AMENDMENTS TO THE DRAWINGS

ANNOTATED SHEETS SHOWING CHANGES**Title: EXTERNAL BLOW OFF CONVERSION
OF COMPRESSOR RECIRCULATION VALVE**

Atty. Ref. 706652US2

FIG. 1
PRIOR ART

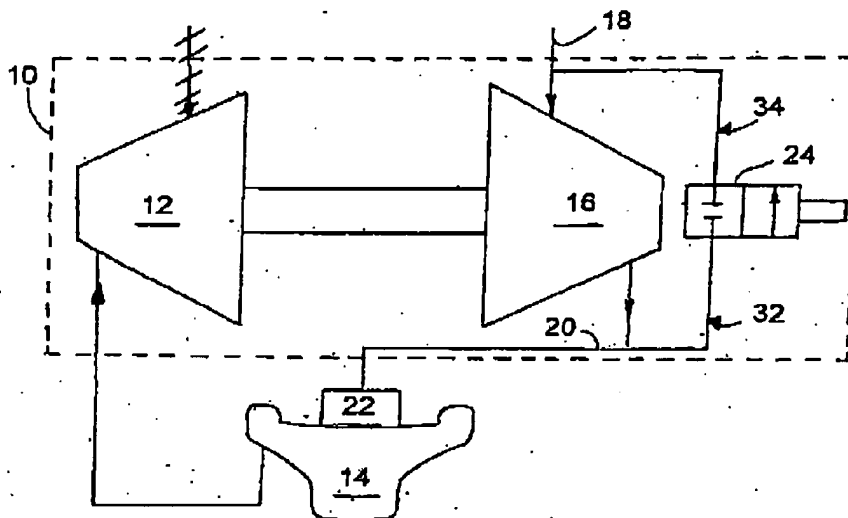
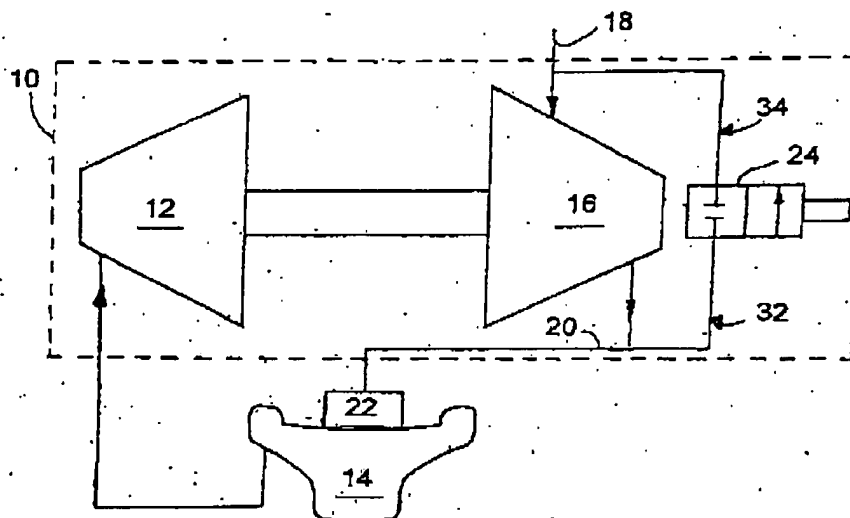
The attached "Replacement Sheets" of drawings include changes to Figure 1. The attached "Replacement Sheets," which include Figures 1-2, replace the original sheets including Figures 1-2.
